March 29, 2022

RE: Design Review Application Project Address: 7950 Bodega Avenue

|    | Prelim Design Review Comments  | Response  |

A1.0

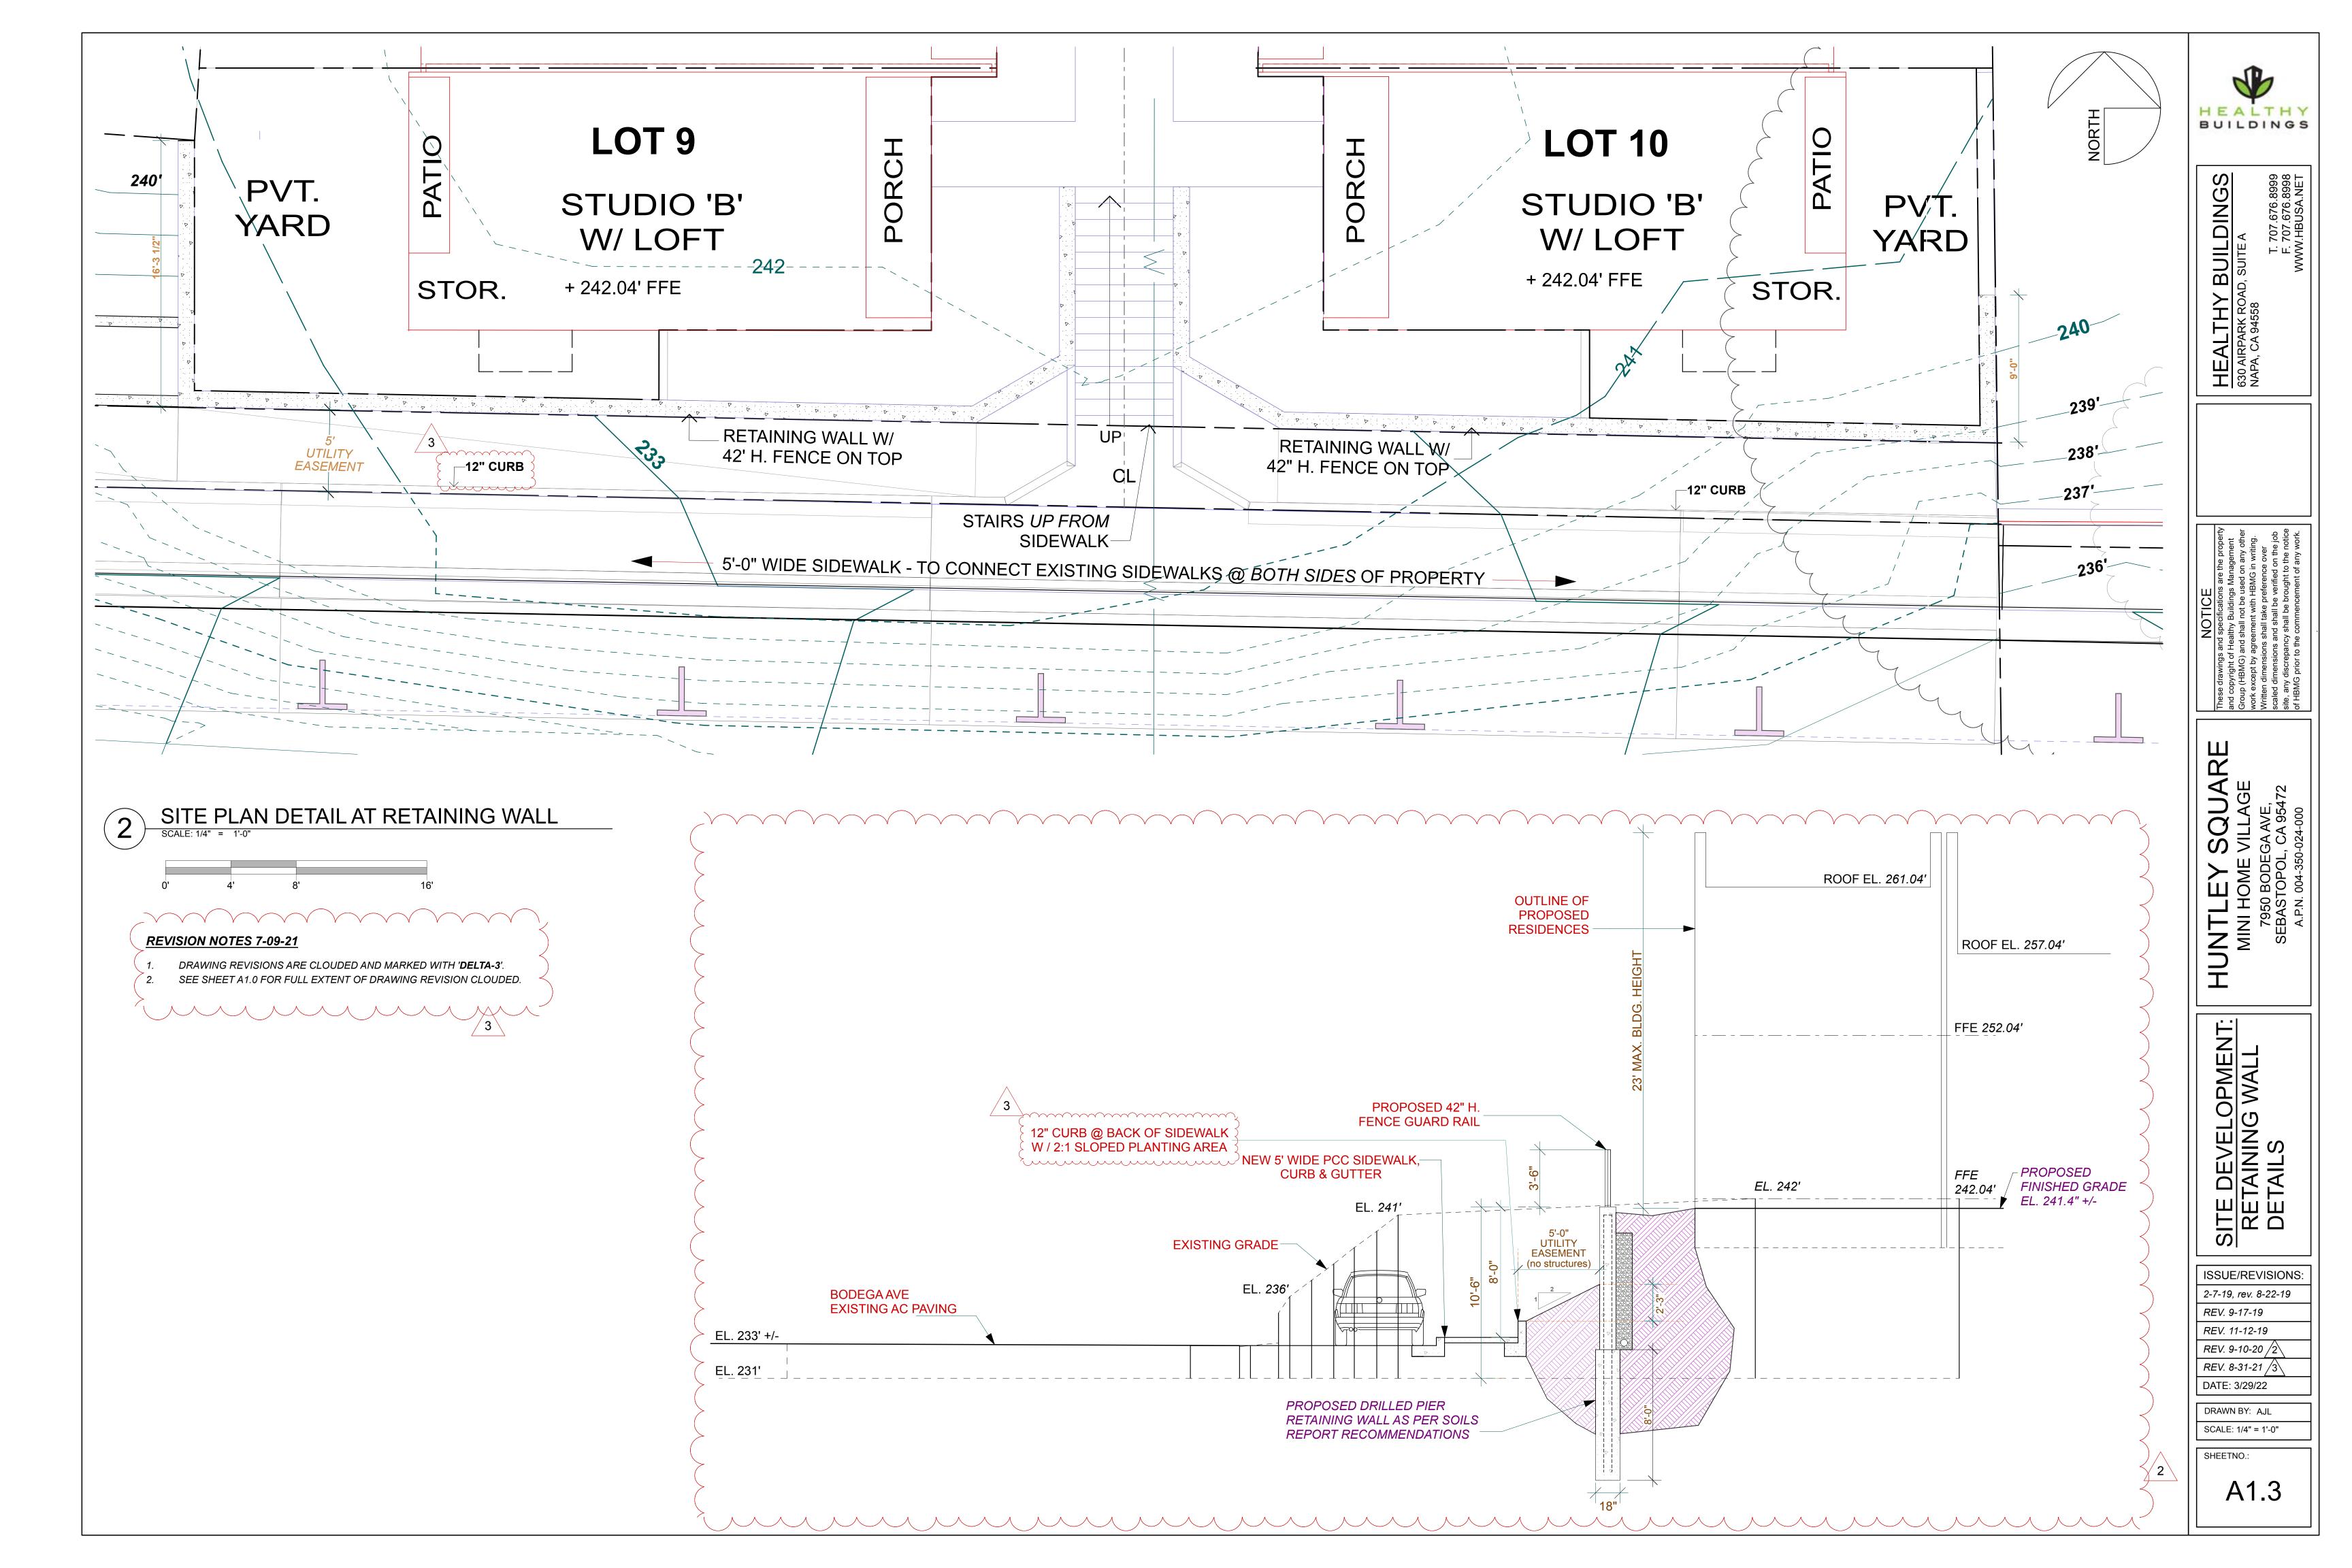
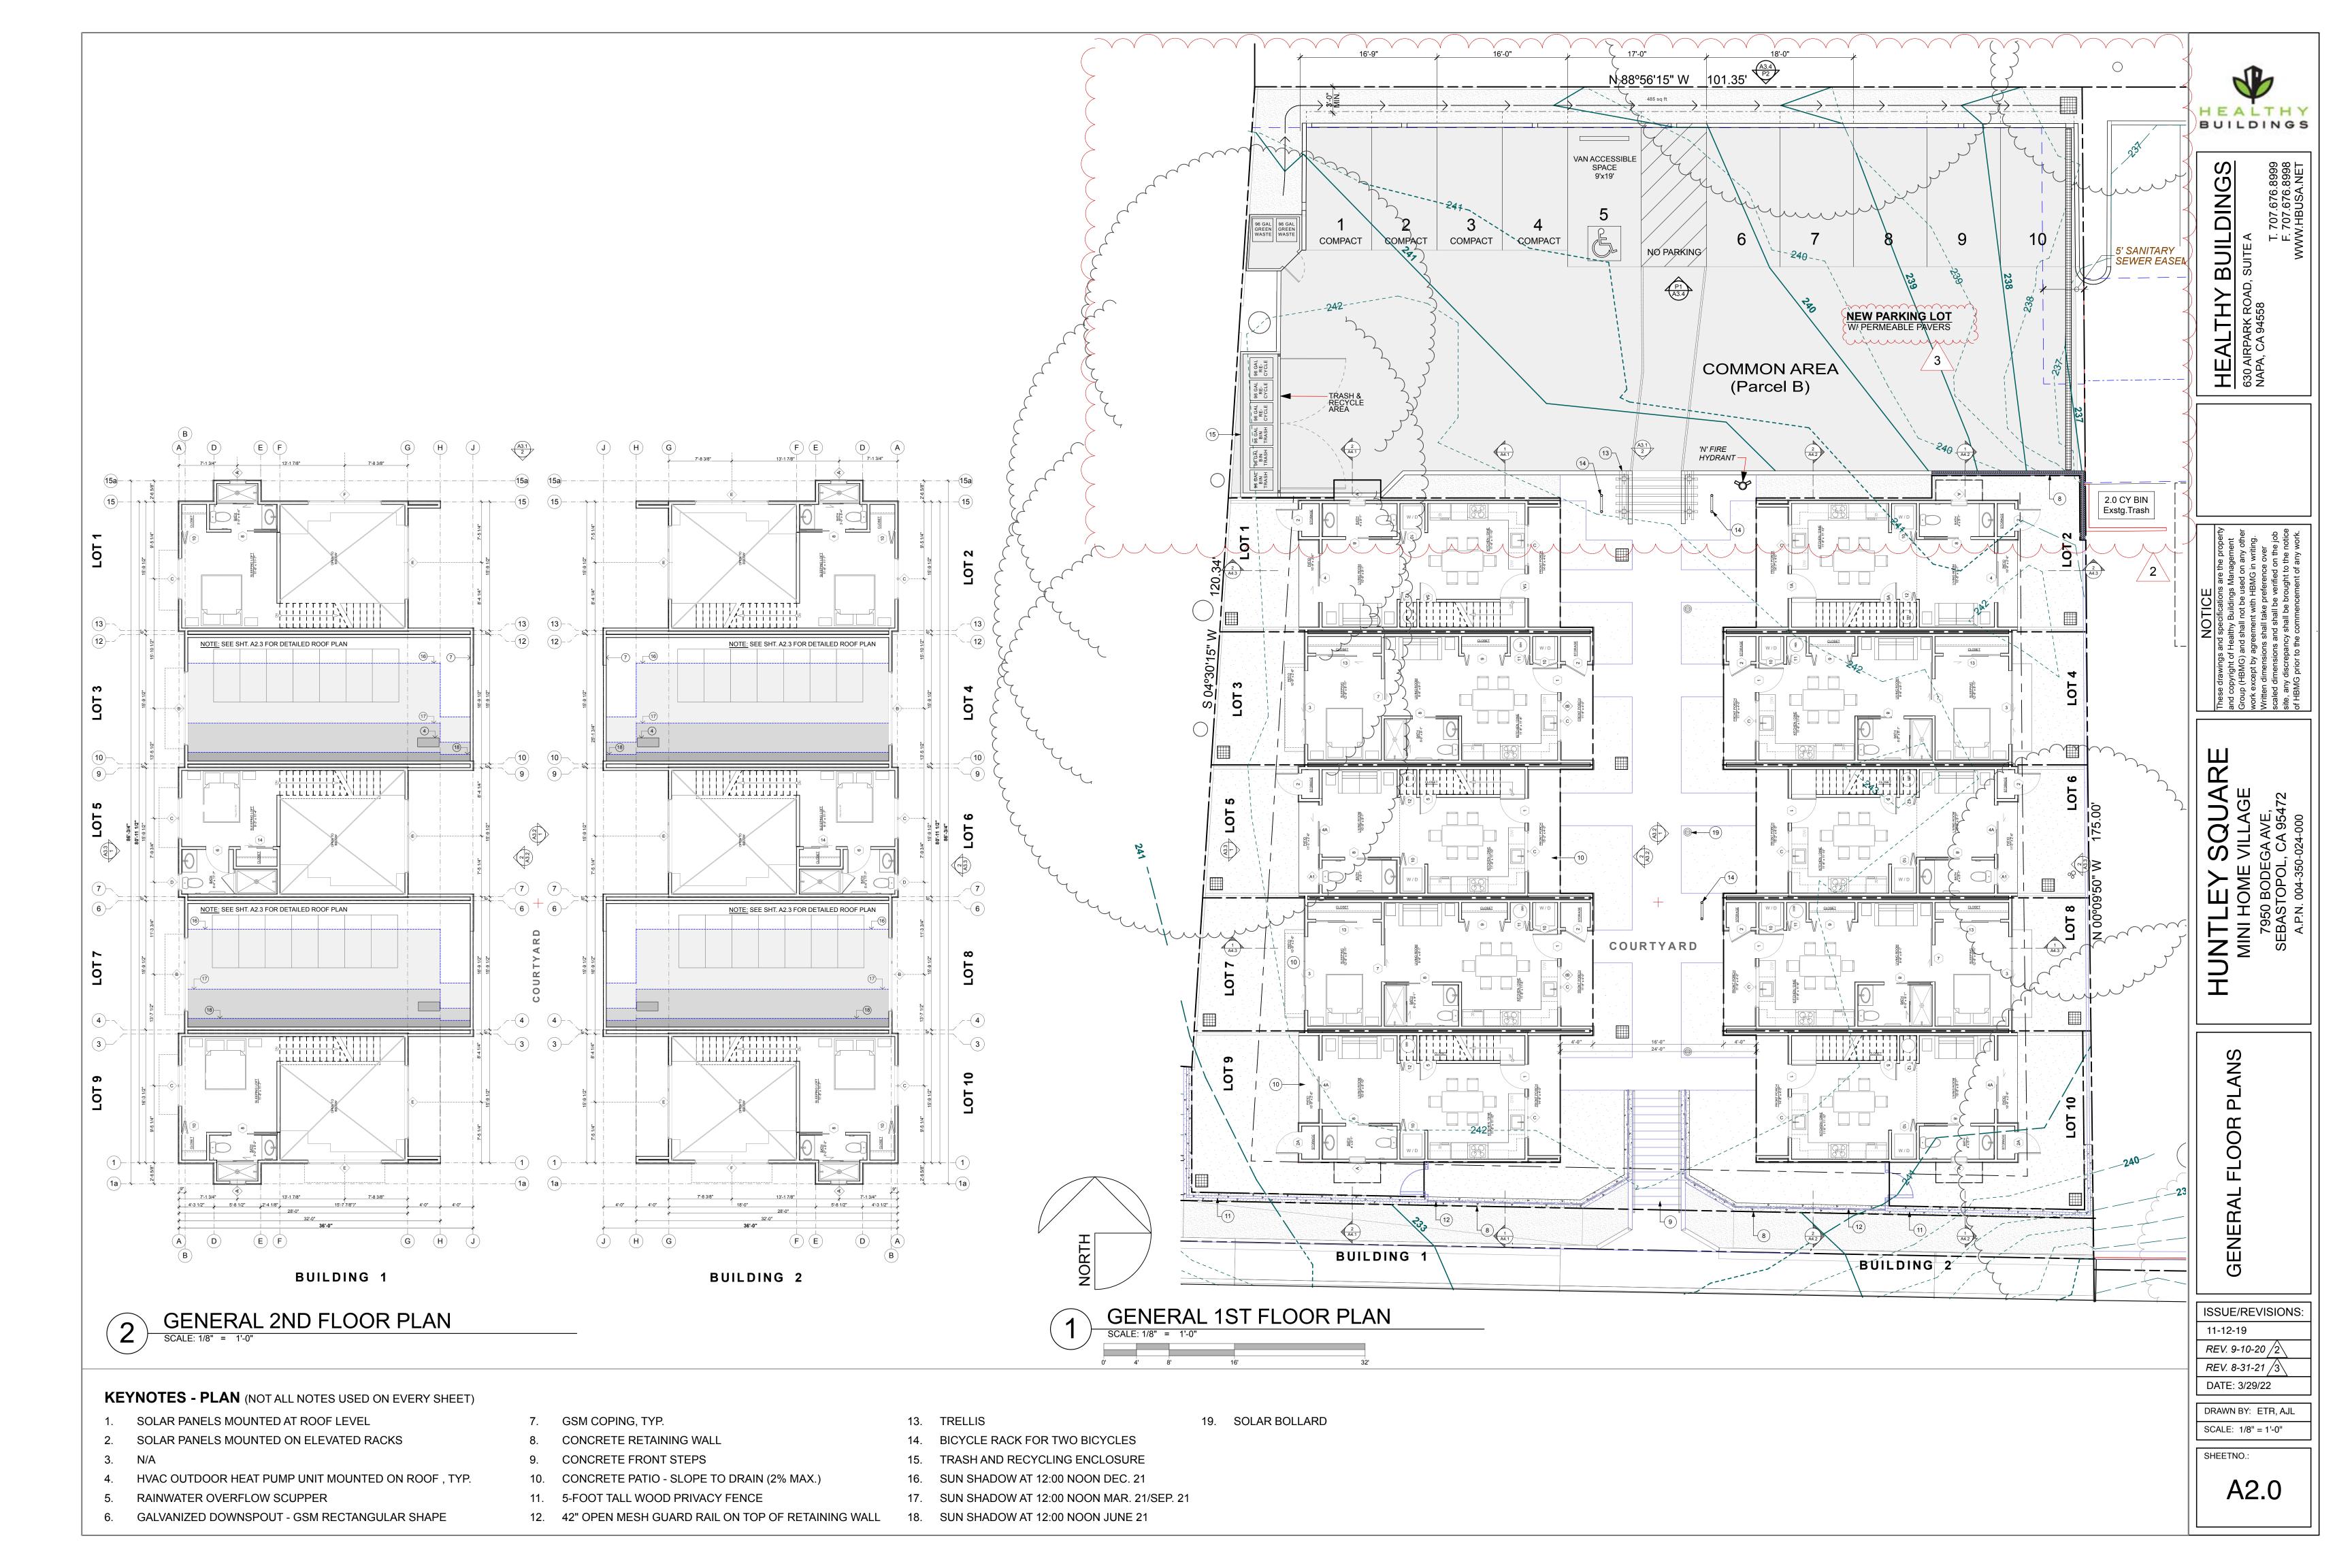
|    | Prelim Design Review Comments  | Response  |
|----|--|---|
| 6  | Plan showing driveway on easement at neighbors property to the east.                                       | Sheet A1.0 and A1.1 shows how the parking area is accessed over the easement on the neighbors property. The easement is 25' wide and the entrance to the new project parking area is 22' wide.  |

A3.4

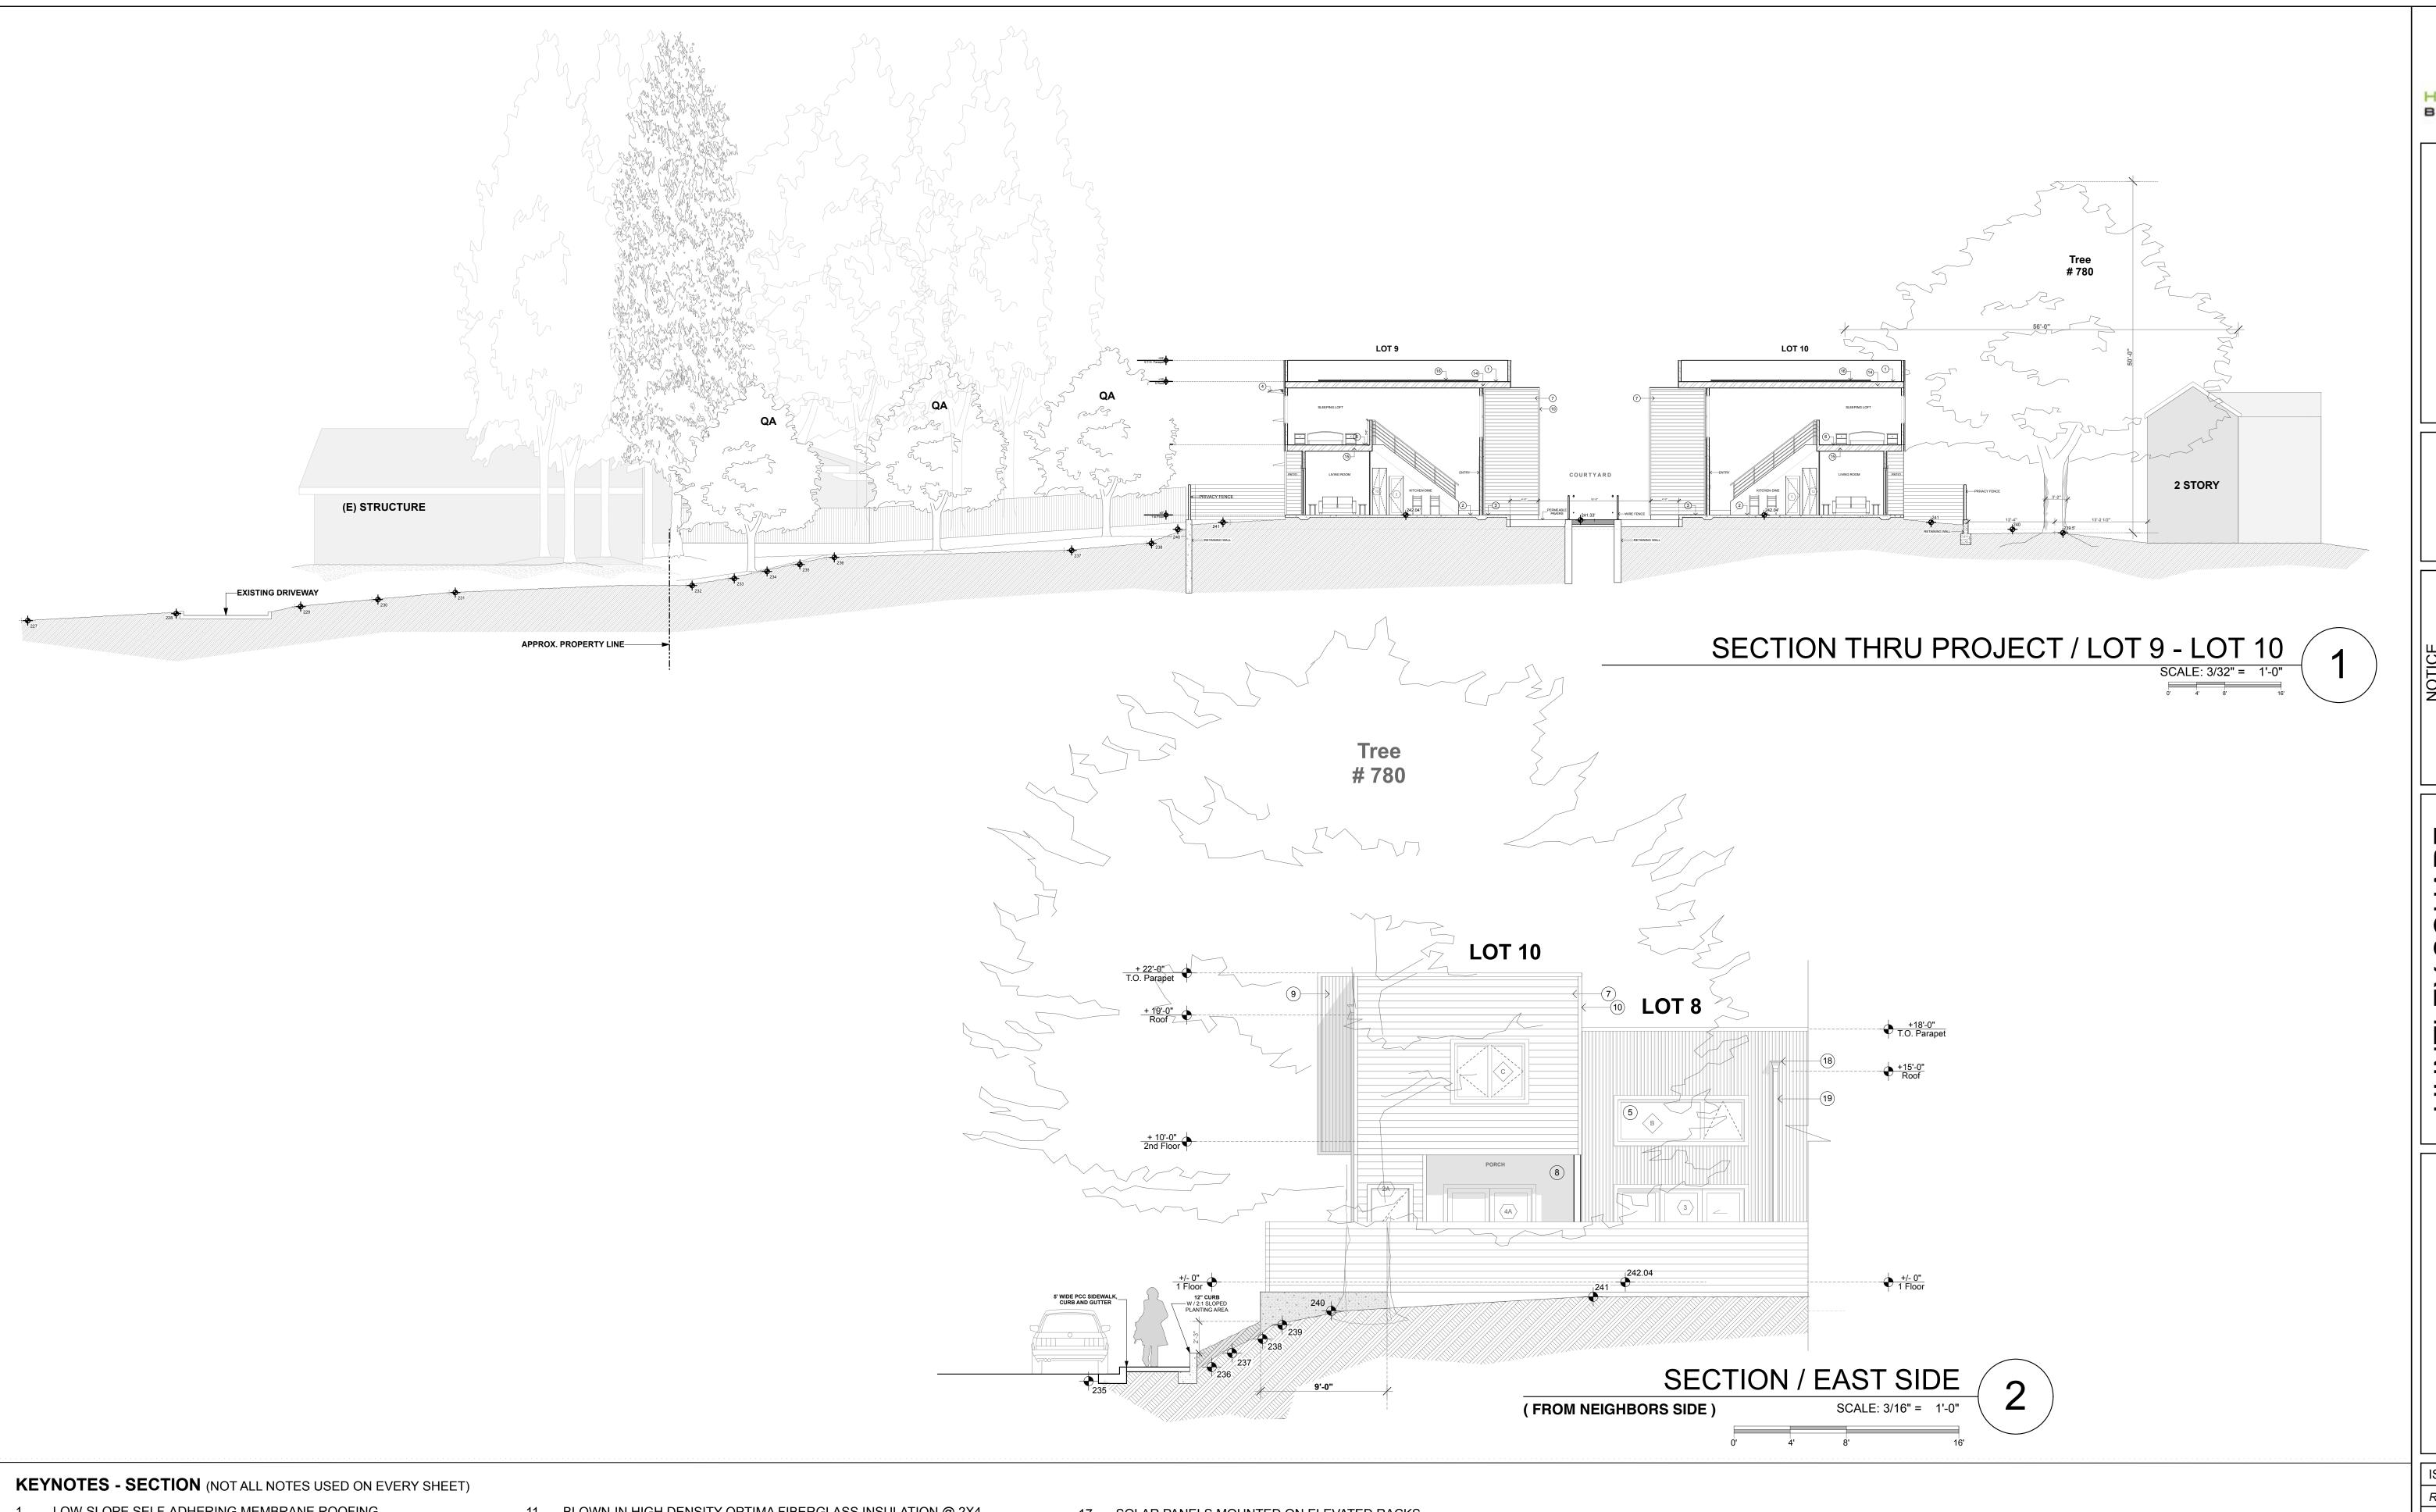
|    | Prelim Design Review Comments  | Response  |
|----|--|---|
| 1  | Tight parking for resindents onsite,<br>how to turn around if no parking<br>space available,               | On sheet A 3.4 we have diagramed how the cars will back out from space #1, (the tightest space) and how a car would turn around if there were no sapces avilable to use by using part of the ADA loading space.   |
